PROJECT: 21 DEANE STREE LOT 1, COTTESLOE 6011  
DRAWING: FIRST FLOOR PLAN  
CLIENT: Kate Moore

# Proposed Two-storey Dwelling with Undercroft Garage

**RE: SUBMISSION ON PROPOSED TWO STOREY DWELLING WITH UNDERCROFT – LOT 18 (NO. 21)  
DEANE STREET, COTTESLOE**

DRAWING: SITE PLAN

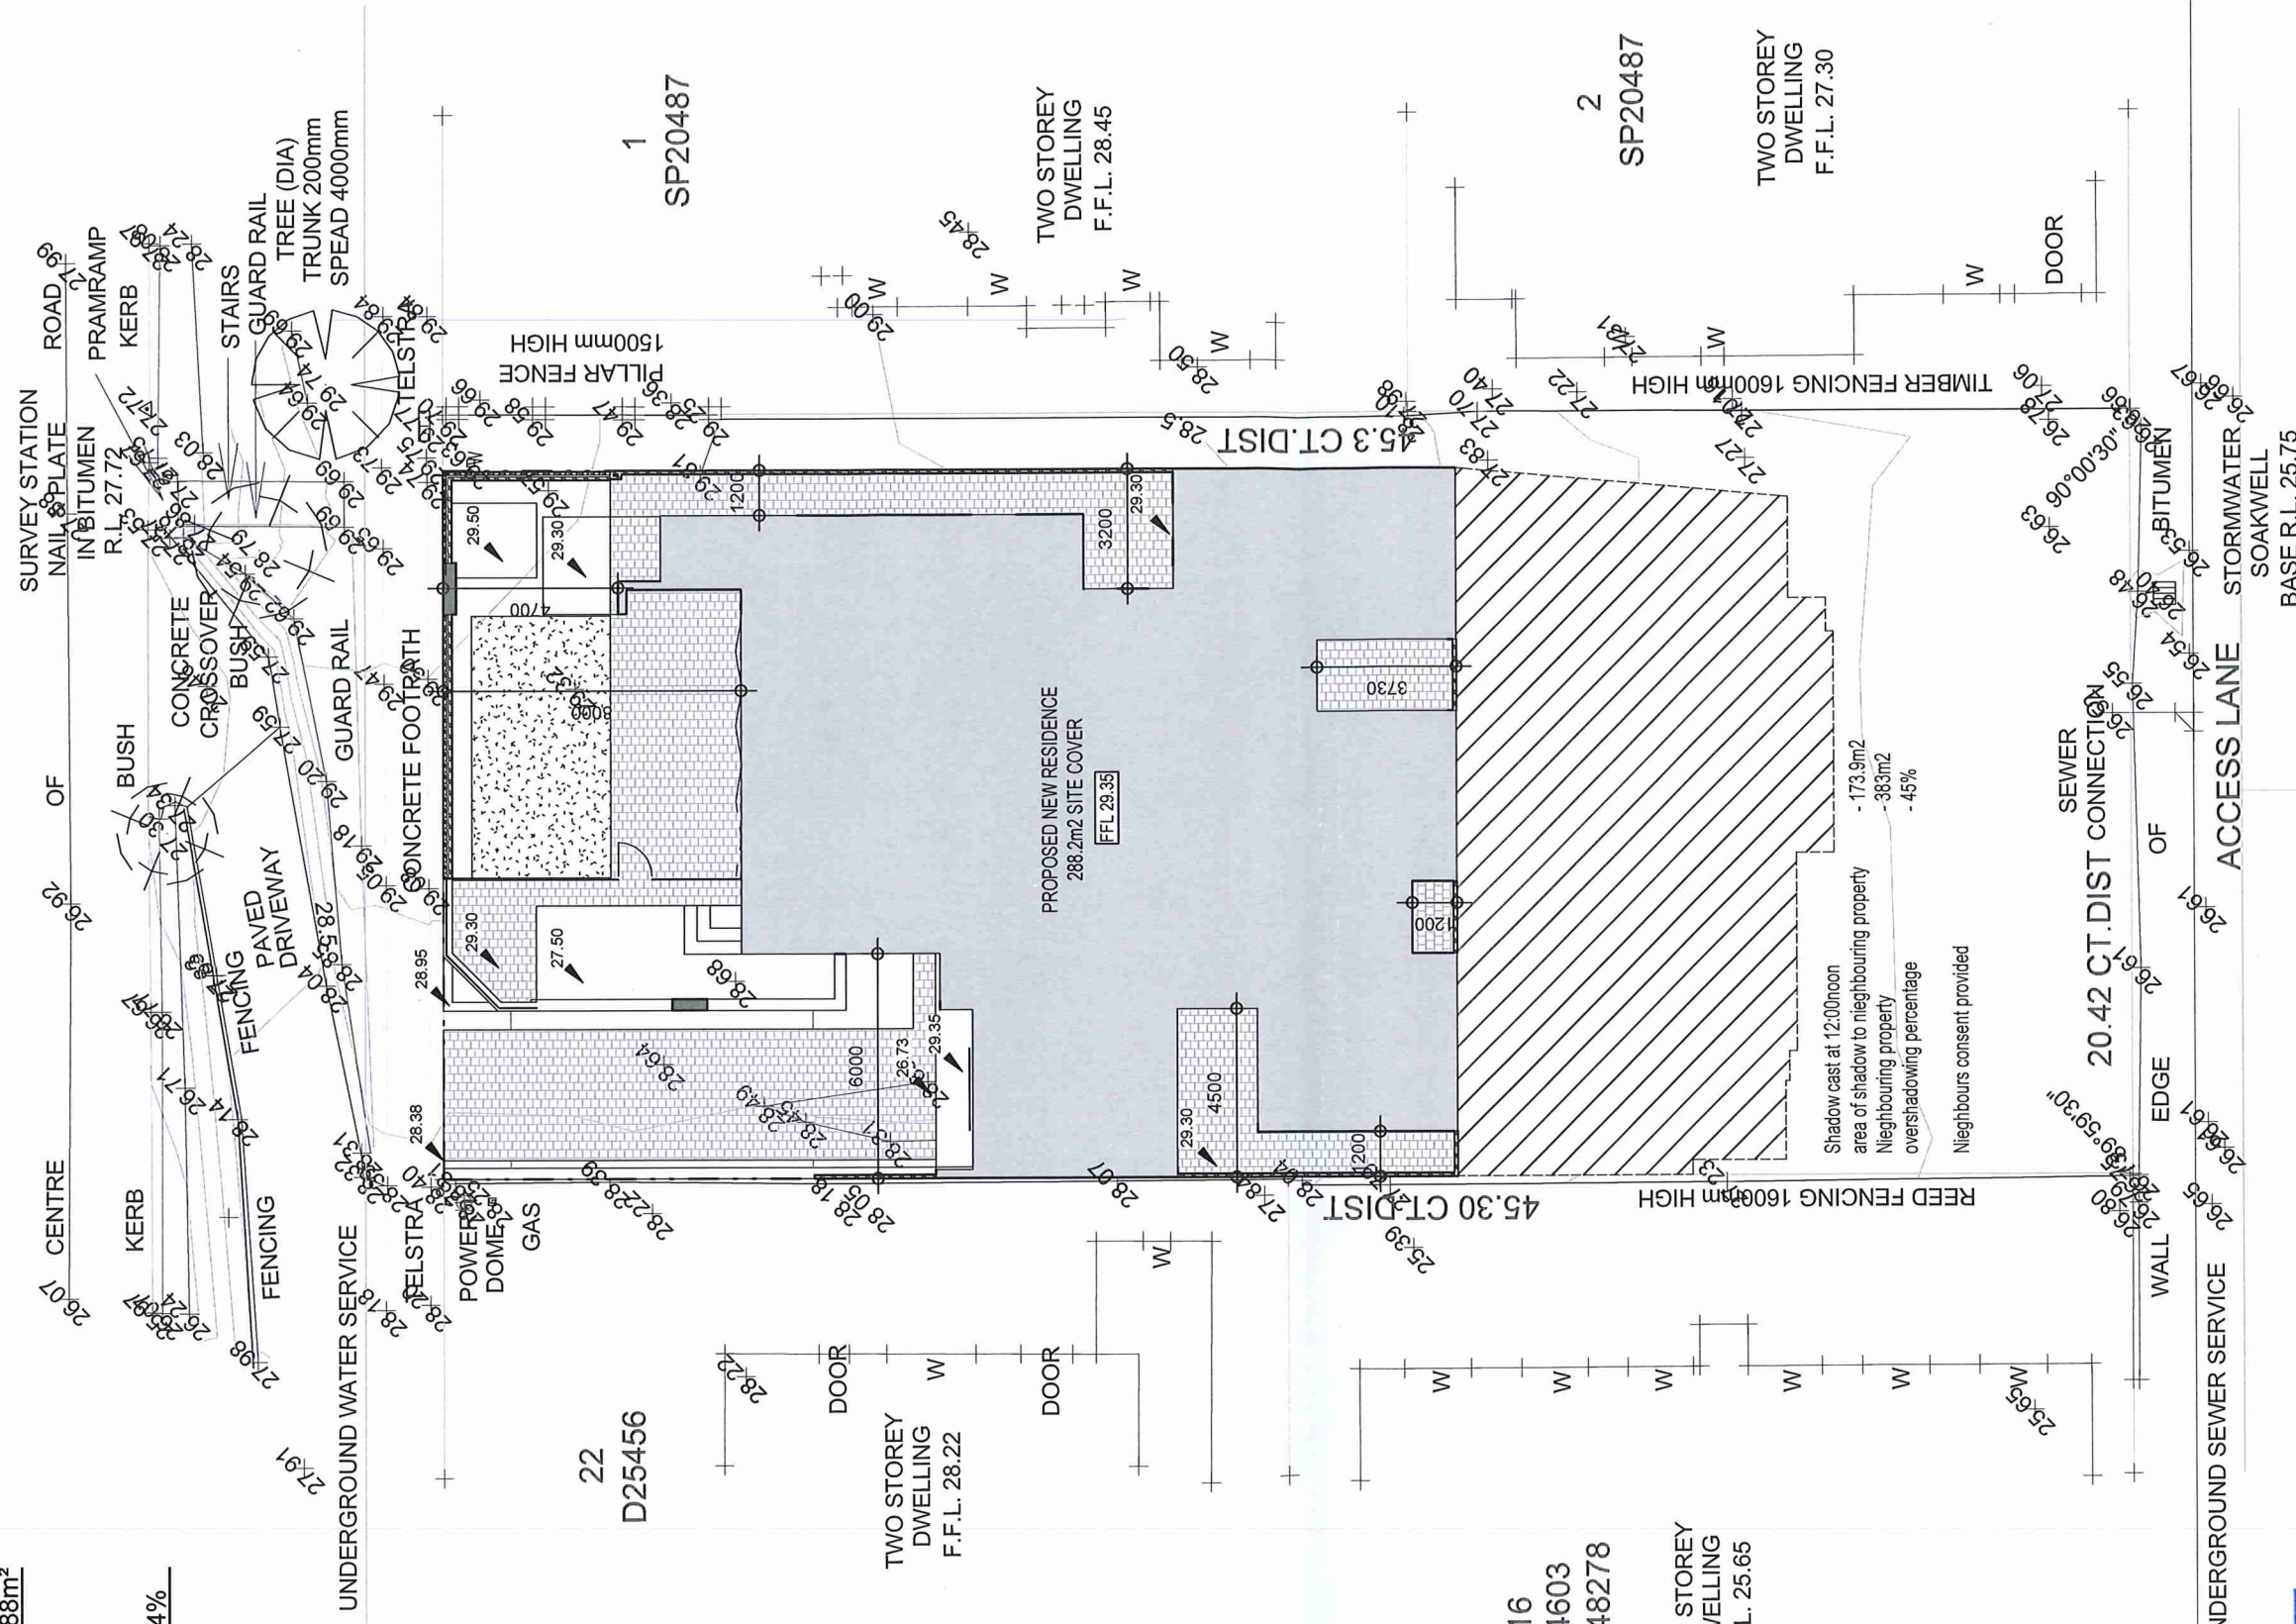
The proposal involves the construction of a new two storey dwelling with undercroft in the northern portion of the subject site. The site area identified for the new dwelling is calculated on Plan DA01 as 515m<sup>2</sup>. The remaining 408m<sup>2</sup> area comprises the balance of the lot to the south of the proposed dwelling and a 1.5m wide pedestrian access leg along the eastern boundary connecting with Deane Street to the north. The development layout on Plan DA01 implies that the land has been subdivided. However, a search of Landgate titles and mapping indicates that the subject site remains as an existing unsubdivided allotment. There is no detail provided as part of the publicly accessible plans and information to confirm whether or not subdivision approval exists for the property.

Based on the spot height provided on Plan DA01, the finished level of the primary outdoor living areas of the ground floor multiple dwellings at 24 Avonmore Terrace is 25.39 AHD. The existing natural ground level on the boundary adjoining 24 Avonmore Terrace has a height of 28.04.

Based on the surveyed lot boundaries shown on Plan DA01, the proposed development at the subject site will extend approximately 5m south of the common boundary between No. 24 Avonmore Terrace and No. 17 Deane Street (refer **Figure 2**). Therefore, the proposed development will be directly adjacent to the north-eastern portion of the building at 24 Avonmore Terrace and will be visible from the east facing habitable room windows and primary outdoor living areas for all four of the multiple dwellings within that property.

As noted previously, the shadow cast at 12 noon on 21 June pursuant to Clause 5.4.2 of the R-Codes will result in a 10% exceedance to the 35% deemed-to-comply provision. As demonstrated on Plan DA01, the total shadow cast on the southern portion of the subject site is 45% or 173.9m<sup>2</sup> of the site area.

It appears that vehicular access is proposed to be provided to Deane Street via the existing driveway servicing No. 17 Deane Street to the north-west of the subject site. Plan DA01 shows the vehicular access point terminating at the northern lot boundary of the subject site where it meets the concrete footpath, however there is no detail demonstrating how vehicle access will be achieved beyond that point. The image at **Figure 5** below demonstrates the level differences in this location which suggest that there will be a need for detailed engineering to achieve manoeuvrability and suitable access gradients for vehicular ingress and egress to the subject site at this point. The image also demonstrates that there would be the need to remove existing vegetation within the verge which has the potential to negatively impact on the established streetscape and amenity of the locality.

Figure 1 – Location Plan

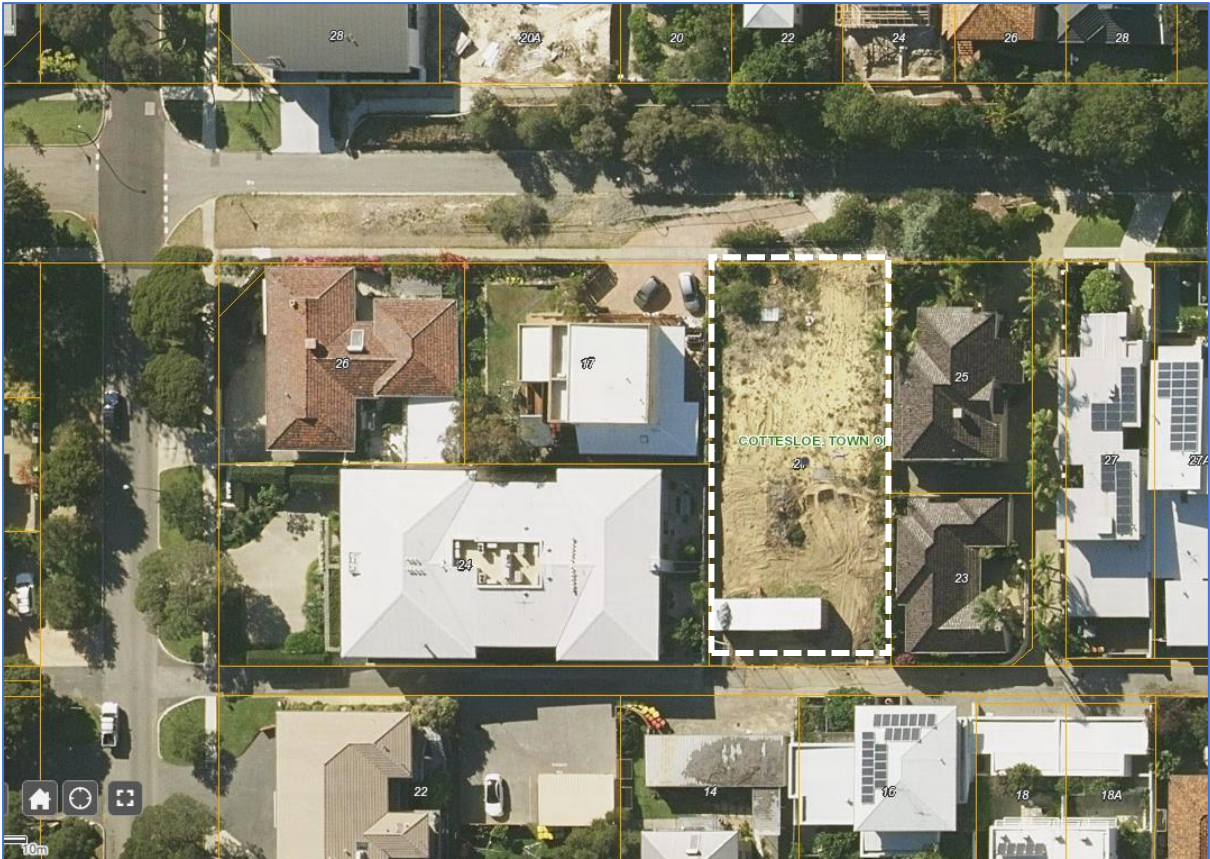
As demonstrated in **Figure 2** above, the proposed southern boundary wall is positioned directly adjacent to the eastern outdoor living areas and east facing habitable room windows on the neighbouring property at No. 24 Avonmore Terrace. The proposed southern boundary wall is set back from the western boundary of the subject site by 1.2m. Along the western boundary, a 2.16m high boundary wall is proposed for a total length of 7.5m which terminates at the southern boundary of the subject site.
